TECHNICAL FEEDBACK FROM ISWM ADOPTERS

WEBINAR

MARCH 30, 2020

Equation (3.2)

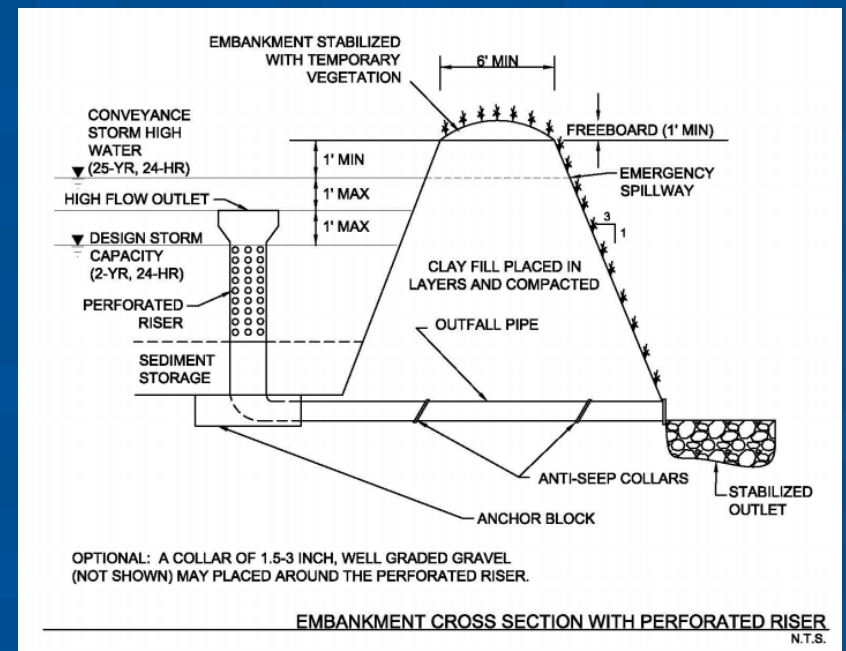
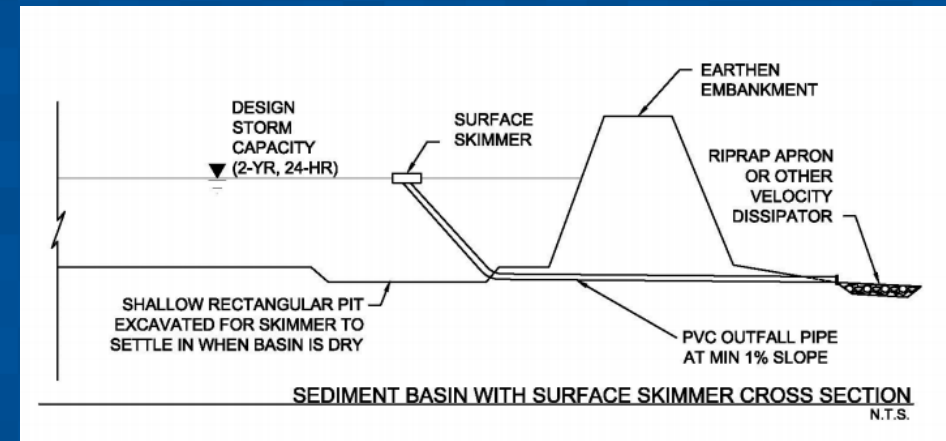
- Section 3.9.7 – Sediment Basin – Design Procedures – Step 1
 - Correct or add reference to *Hydrology Technical Manual* for required volume calculations
 - Where did this Equation (3.2) come from?

- Recommend update to manual
 - Add wording to Section 3.9.7 page CC-125

“Please refer to Section 1.0 of the Hydrology Technical Manual to determine the method appropriate to size the required volume for your storage facility. Please refer to corresponding section in Hydrology Technical Manual to calculate required volume.”

Figure B-2. Properties of a parabolic curve.

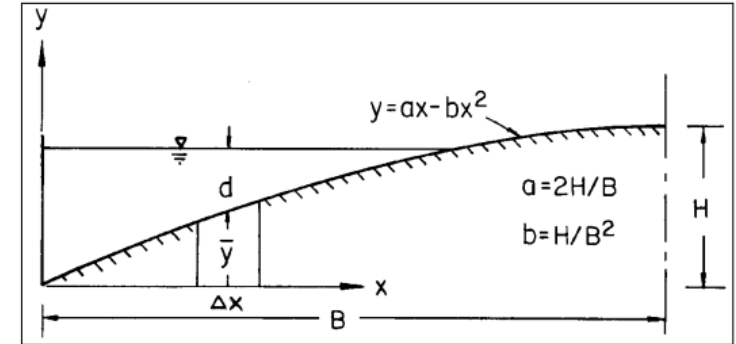
- Need an on grade inlet calculation for parabolic crowned streets - check with your development staff

- Recommend update to manual
 - Add reference to HEC-22 FHWA Urban Drainage Design Manual Section B.3 – Spread-Discharge Relationships for Parabolic Cross Sections
